Rezoning Transportation Analysis

Petition Number: 2018-122

Revision Log:	Date	Description
	10-17-18	First Review
	11-19-18	Second Review

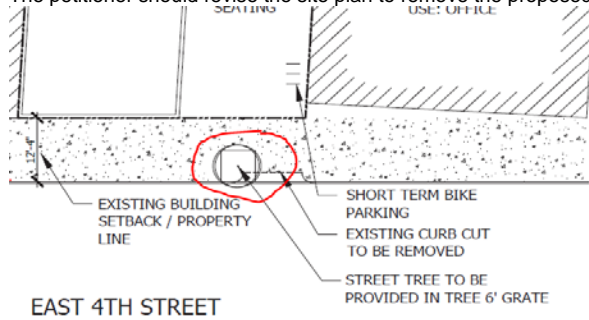
- ~~**Curbline** The proposed zoning district has a setback measured from back of the existing or proposed future curbline. The location of the future back of curb on East 4th street is 24.5' from centerline and is in its existing location on South Torrence Street.~~

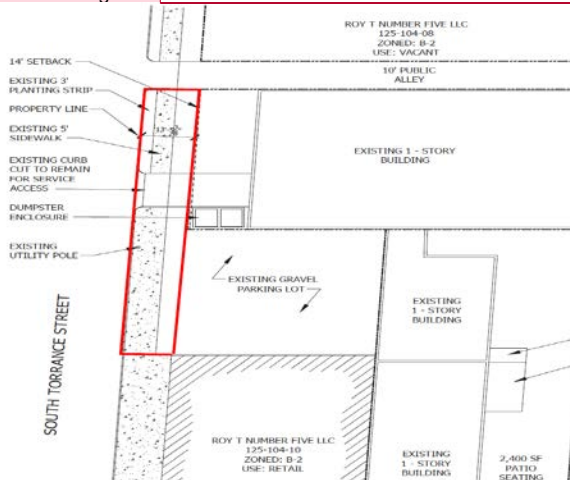
2. ~~Traffic Study~~ A Traffic Impact Study is not necessary for the complete review of this petition.
3. The petitioner should revise the site plan and conditional note(s) to install 2 ramps at the corner of South Torrance Street and East 4th Street.
4. The petitioner should revise the site plan to remove the proposed street tree.

5. The petitioner should revise the site plan and conditional note(s) to upgrade frontage along South Torrance Street to have an obstructed 16' wide amenity zone at the back of curb to accommodate for sidewalk and tree grates.

Commented [W11]: Petitioner wants to opt out of street scape as it relates to MUDD zoning 9.8506. Petitioner called and stated they do not own gravel parking adjacent but what is being requested should fit in right-of-way. At minimum 6' back of curb sidewalk should not be allowed
